Re: PUCO Case No. 16-2438-RR-FED- In the Matter of a Request for the Installation of Active Warning Devices at IORY Railroad Crossings, DOT#151-970W, Cuba Road, & DOT#151-957H, Doan Street, in Clinton County, Ohio.

TO: Randall Schumacher, Supervisor, Rail Division, PUCO
FROM: Cathy Stout, Manager, Safety Section, ORDC
BY: Greg Gronbach, Project Manager, Safety Section, ORDC
SUBJECT: Clinton County, Cuba Rd, IORY DOT # 151970W, PID 103318
DATE: December 12, 2016

TO: Randall Schumacher, Supervisor, Rail Division, PUCO
FROM: Cathy Stout, Manager, Safety Section, ORDC
BY: Greg Gronbach, Project Manager, Safety Section, ORDC
SUBJECT: Clinton County, Doan Street, IORY DOT # 151957H, PID 103223
DATE: December 12, 2016

CALCULATED TAS CHECKED JSB	CUBA ROAD - MP 49.31 (151970W) PROPOSED SITE LAYOUT	CUBA ROAD SIGNAL UPGRADE	<div><div>2</div><div>2</div></div>

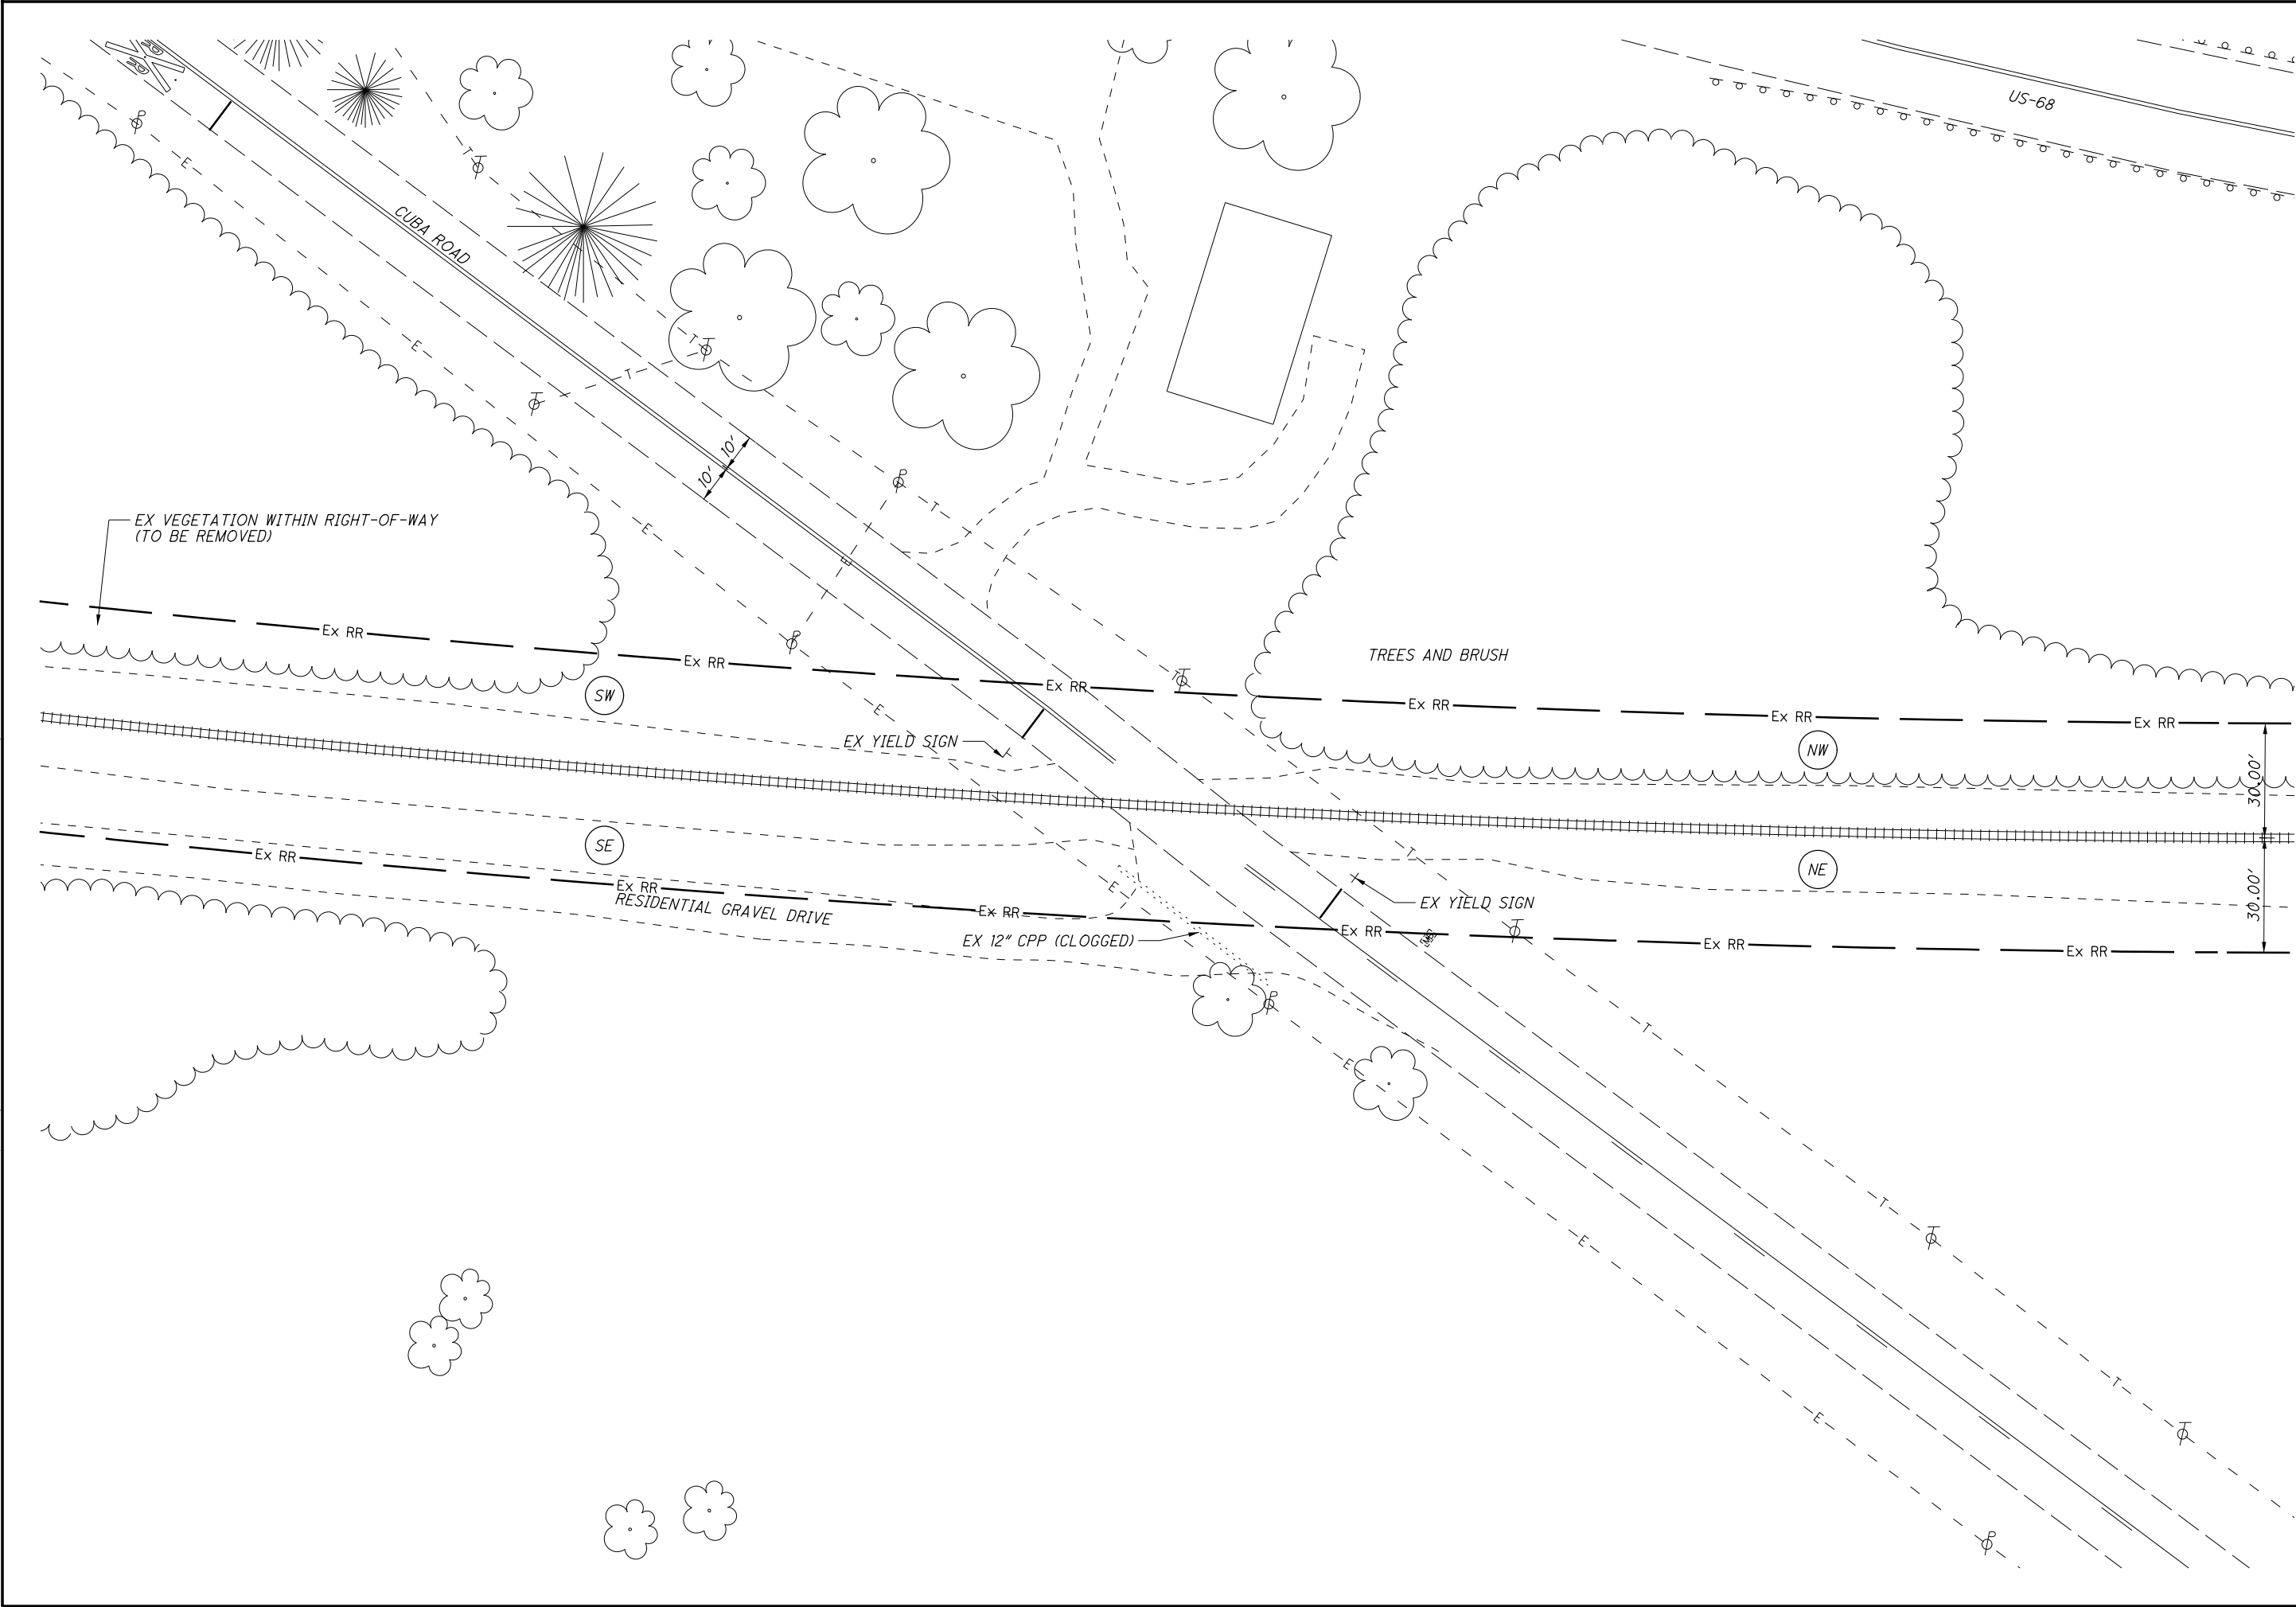
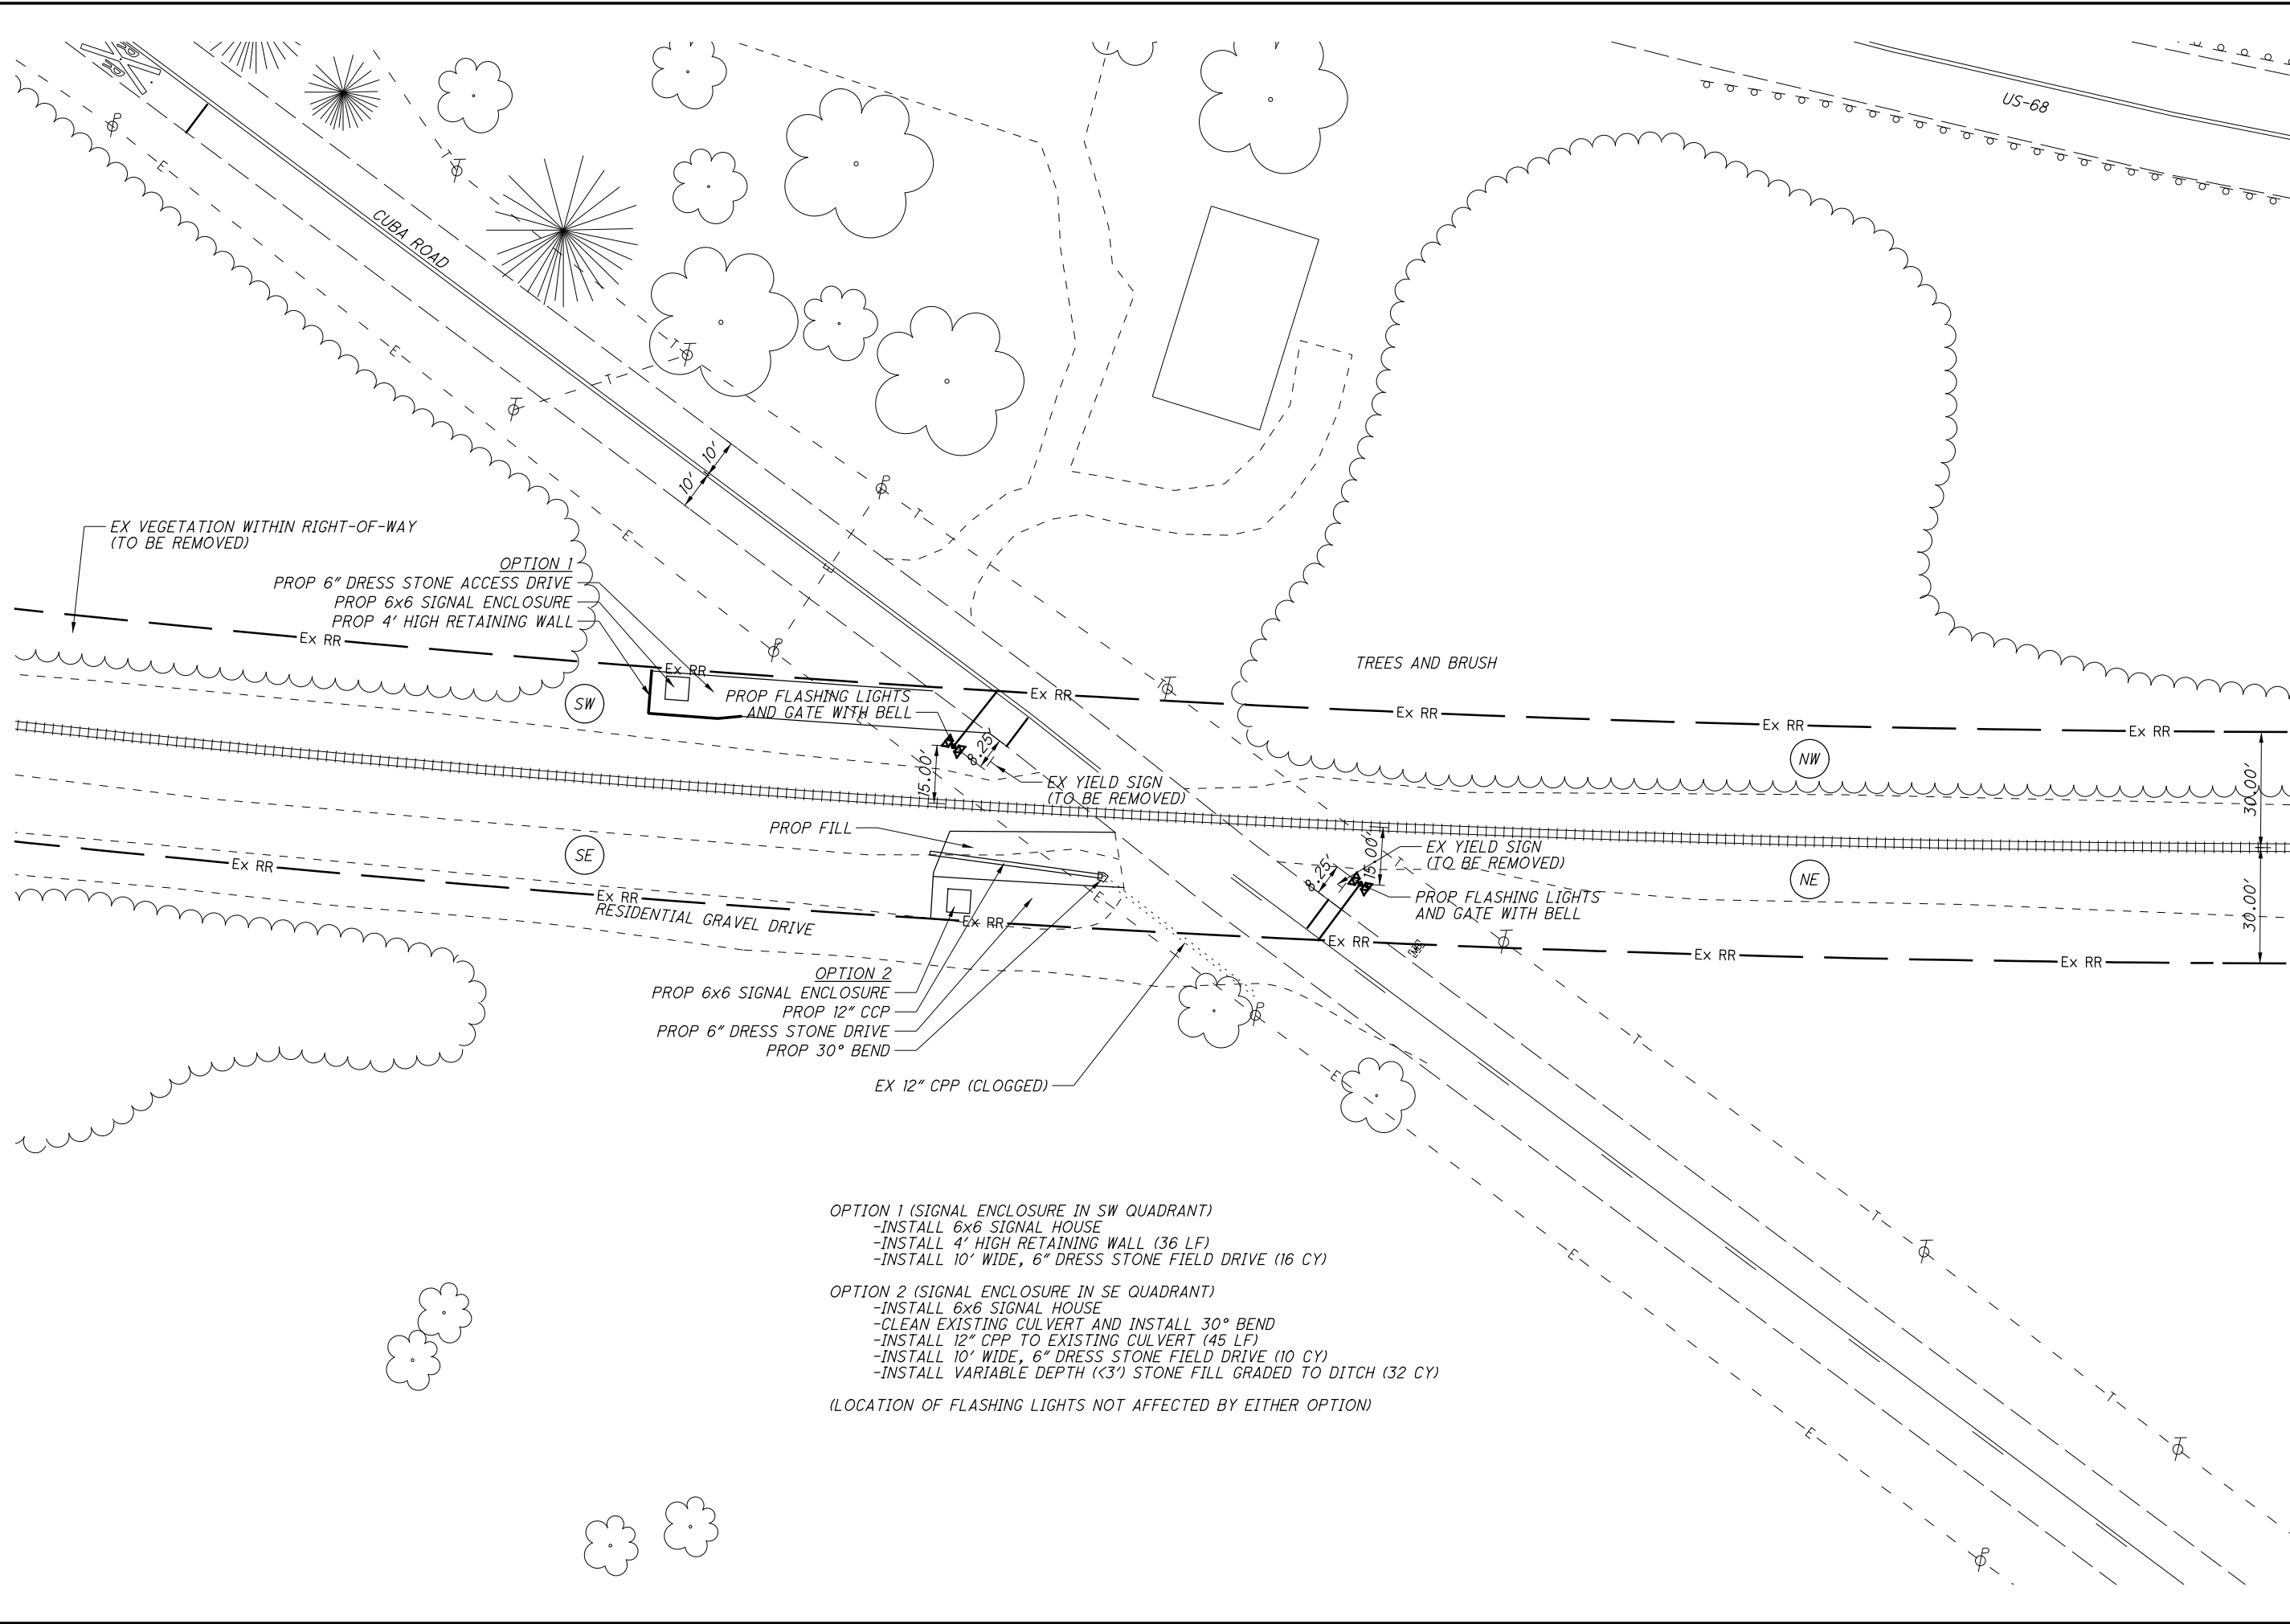
The plan and estimate dated November 18, 2016, for the referenced project has been reviewed and is acceptable. Indiana & Ohio Railroad (IORY) may proceed with the construction of the proposed grade crossing warning system in accordance with the abbreviated plan. Construction may include but is not limited to circuitry design, installation of service poles, procurement of materials and signal construction. Please note ODOT Railroad Audit Circular No.4 Subcontracted Costs for Railroads and accordingly provide ORDC with any relevant bid documents and bid tabs pertaining to this project. This authorization is made with the stipulation and understanding that the approved estimate may contain entries for items or activities that may be cited and found to be ineligible for federal participation during the project audit. Reimbursement of eligible actual cost is limited to \$200,000.00 and will be adjusted based on bid tabulations if applicable. Additional costs must be approved in writing by the Ohio Rail Development Commission (ORDC) prior to being incurred. Emergency verbal authorizations by ORDC may be permitted and will be confirmed by ORDC in writing within ten (10) business days of the verbal approval.
